GLA Stage 1 - Response

DATE:	14 April 2023	CONFIDENTIALITY:	Restricted
SUBJECT:	Berol Quarter (Berol Yard) – GLA Stage 1 Response		
PROJECT:	70094918	AUTHOR:	Mark Cottray
CHECKED:	Sam Tearle	APPROVED:	Mark Cottray

Figure 2: Josta 2-Tier Cycle Rack (L) Vs Standard 2-Tier Cycle Rack (R)

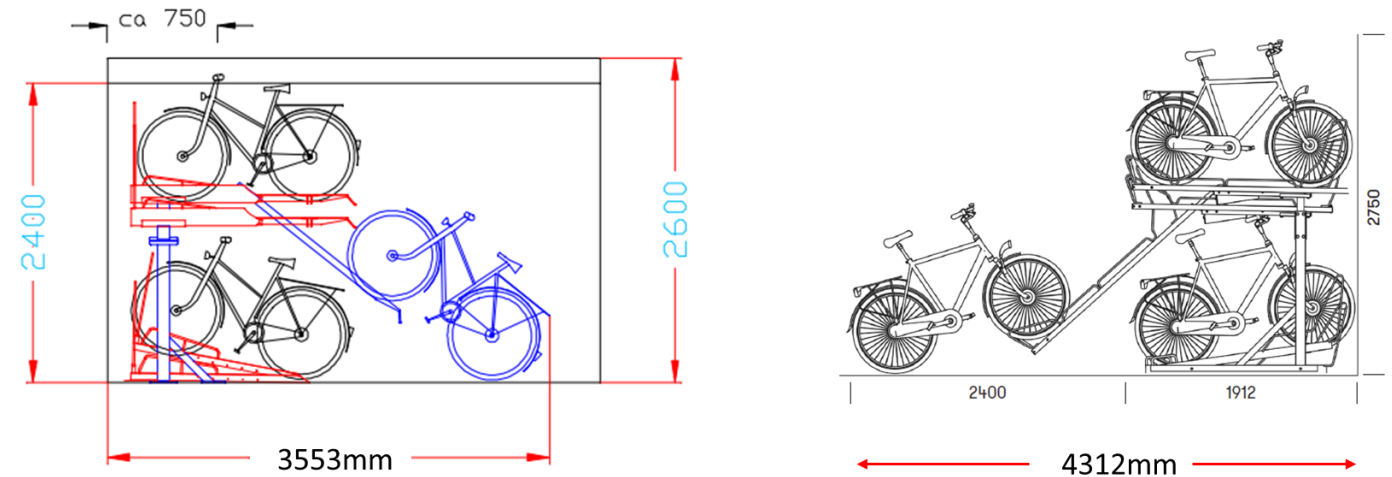
70. TfL has concerns over the quantum and design of the cycle parking. The quantum on the plans appears to be below London Plan minimum requirements. In addition to this, design does not accord with the London Cycle Design Standards (LCDS). Further detailed will be within the borough comments.

The proposals assume the use of a Josta 2-tier cycle racks (or equivalent), which are considered an innovative solution to provide high quality cycle parking for sites with limited space. **Figure 2** below illustrates:

- The Josta 2-tier cycle rack that shows the rear of the bike extends out 3553mm from the wall when the rack is pulled down; and
- Another with a more standard 2-tier system that shows the rear of the bike extends out 4312mm from the wall when the rack is pulled down.

The image illustrates the advantages of the Josta 2-tier cycle rack system with its compact footprint, which is achieved by having the top rack sit higher off the floor than other more standard systems and hence needs less operating space than other systems. It highlights that not all 2-tier systems are the same and some will need a wider walkway.

Noting the above, the Applicant concludes that 2.5m aisle width can provide high quality cycle parking to encourage active travel, without it resulting in a detriment impact on the topics listed above.
